CHESTER CYCLING CAMPAIGN

Route: Backford to Sainsbury's Roundabout, Boughton. A41.

This study attempts to identify the existing infrastructure and also to identify some of the current major difficulties with the route from Backford Cross as far as the A56 Hoole Roundabout. It suggests remedies, some of which could be effected quickly and cheaply, some which could be factored in to routine maintenance schedules and some which may require long term planning and significant funding.

A5117/A41 Backford roundabout.

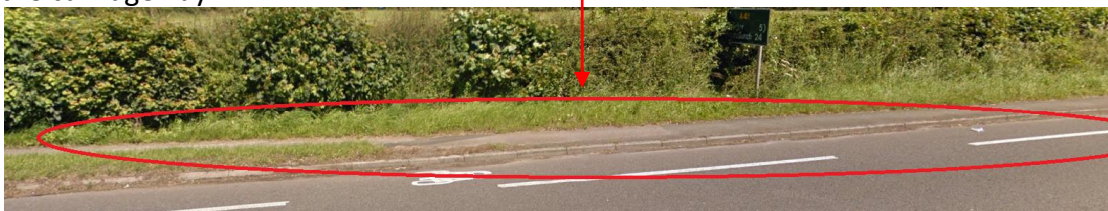
The footpath provides an off-carriageway route on SE segment of the roundabout, but feeds back on to the A41 some 20m before the cycle lane white lines start. The footpath is not in great condition, but there is no ramp or dropped kerb to facilitate access to the on-road lane at this point – the first such access is significantly further down the road.

An angled dropped kerb at the point shown below (just beyond the end of the purple line in the picture above) is needed to facilitate access to this lane. Ideally, of course, a fully fledged Shared Use Path (SUP) would be installed on the verge and off the carriageway.

Whitby Lane (A5032) traffic lights.

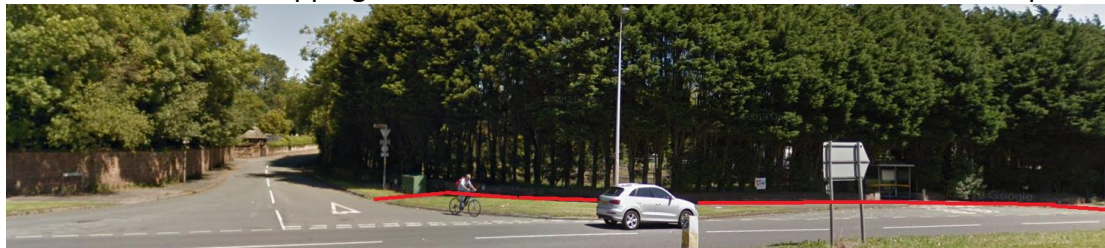
There is an Advanced Stop Line (ASL) on the A41 at these lights which will suffice for confident cyclists. But for the less confident (or mobility scooter users), there are raised kerbs (at points marked X) which prevent access to the other side. The work completed at this junction in 2020 did not address the problems presented by these kerbs.
